INNER WEST COUNCIL

DEVELOPMENT ASSESSMENT REPORT

Application No.	D/2018/657
Address	42-48 John Street, LEICHHARDT
Proposal	Demolition of existing structures, construction and strata subdivision of mixed use development comprising 15 x light industrial units, 1 x take away food and drink premises, 16 x business/office premises for creative purposes, parking and loading facilities.
Date of Lodgement	17-Dec-2018
Applicant	Aydan Two Pty Ltd
Owner	Aydan Two Pty Ltd
Number of Submissions	First notification period: 49 Objections and 1 letter of support Second notification period: 24 Objections.
Value of works	\$8,640,207
Reason for determination at Planning Panel	Number of submissions
Main Issues	Contamination, impacts to car parking and traffic, impacts to adjoining properties
Recommendation	Refusal
Attachment A	Conditions of consent (if the development is not refused)
Attachment B	Plans of proposed development

Figure H – View from front porch of No. 38 Emma Street

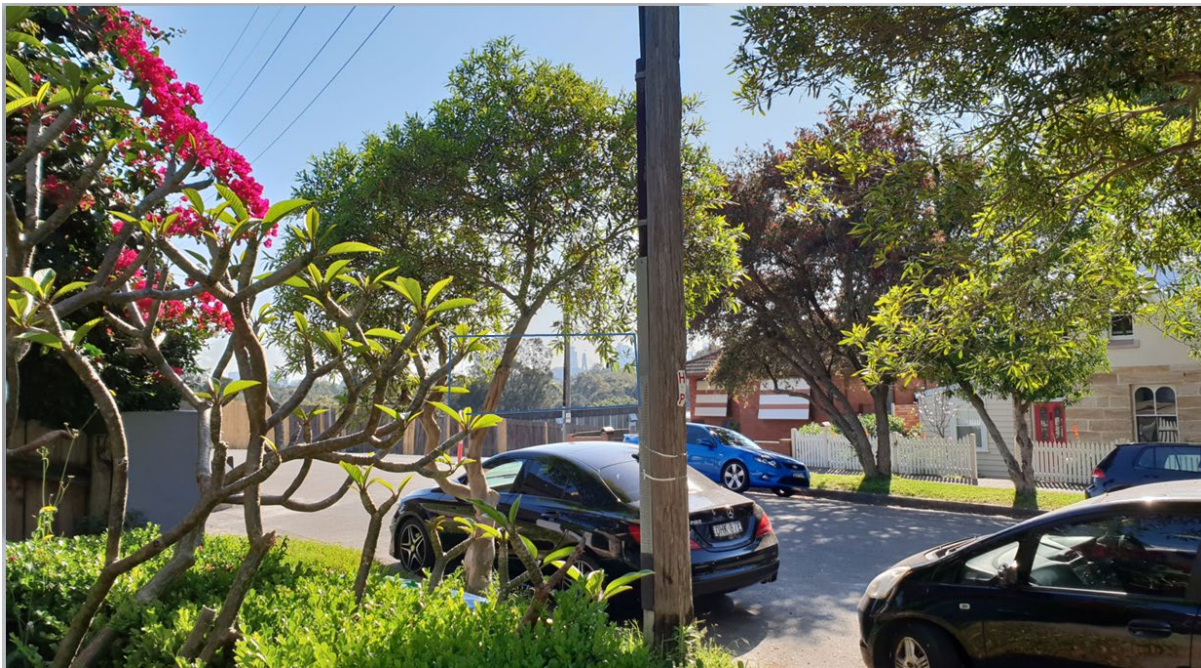
The property at 38 Emma currently enjoys partial views of the city skyline, Centre Point Tower, the Harbour Bridge and the ANZAC Bridge. The best views are obtained from the front porch and the first floor bedroom. In this regard, the views to the city skyline and Centre Point Tower from the first floor bedroom is likely to be retained, however the partial views to the ANZAC Bridge and city skyline are likely to be impacted.

Figure O – View from first floor bedroom window of No. 36 Hill Street

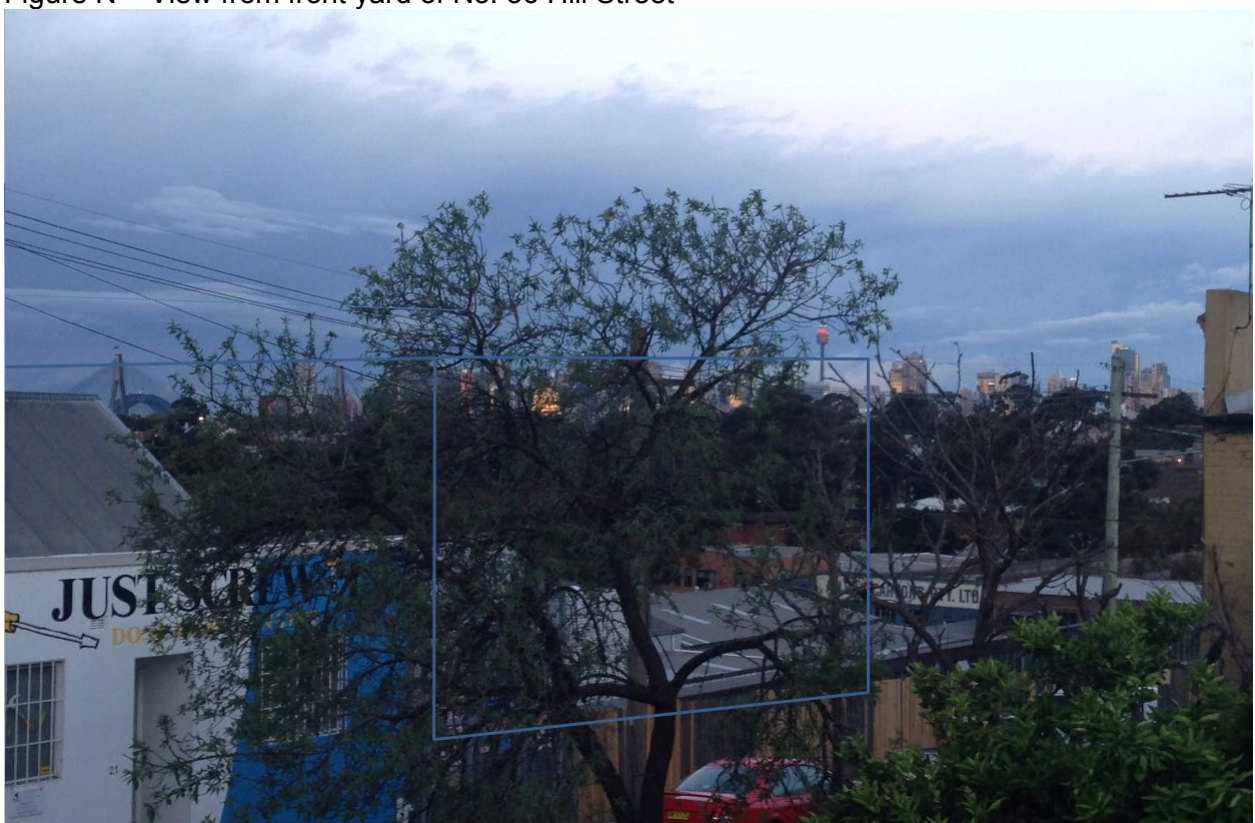
From the objector's photo from the first floor bedroom window, the property at 36 Hill Street currently enjoys partial views of the city skyline, the centre point tower, the harbour bridge and the ANZAC bridge. The proposed building located on the western side of the proposed site is likely to obstruct these views.
